SIB 34 07 24

2025-07-17

RECALL 24V-739: INTEGRATED BRAKE SYSTEM (IB)

This Service Information Bulletin (Revision 6) replaces SI B34 07 24 **dated May 2025**.

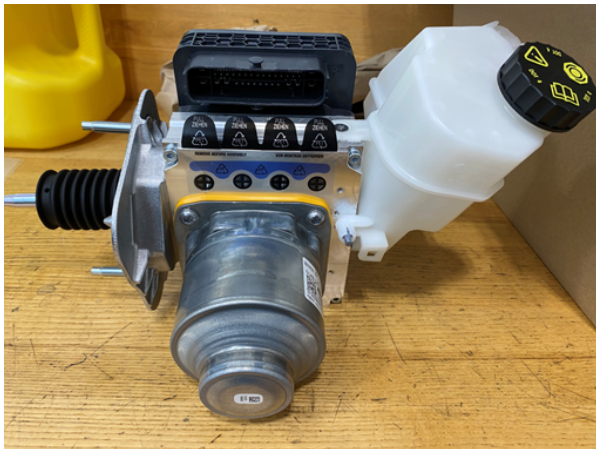
Replace the IB with either a “wet” pre-filled unit or a “dry” unfilled unit.

“Wet” IB pre-filled: Brake fluid reservoir is filled (arrow) and brake fluid line ports are plugged with bolts (circled).

“Dry” IB unfilled: Brake fluid reservoir is empty; brake fluid line ports are sealed with labels.

5B67B85
5B69D65
5B6E463
5B6E465
5B6E467
5B69D61
5B69D63
5B6F947
5B72715
5B72716
5B6F943

5B3C874
5B3C857
5B421D0
5B3C859
5B6C7F1
5B6C7F2
5B6C7F3
5B6C7F5
5B6A736
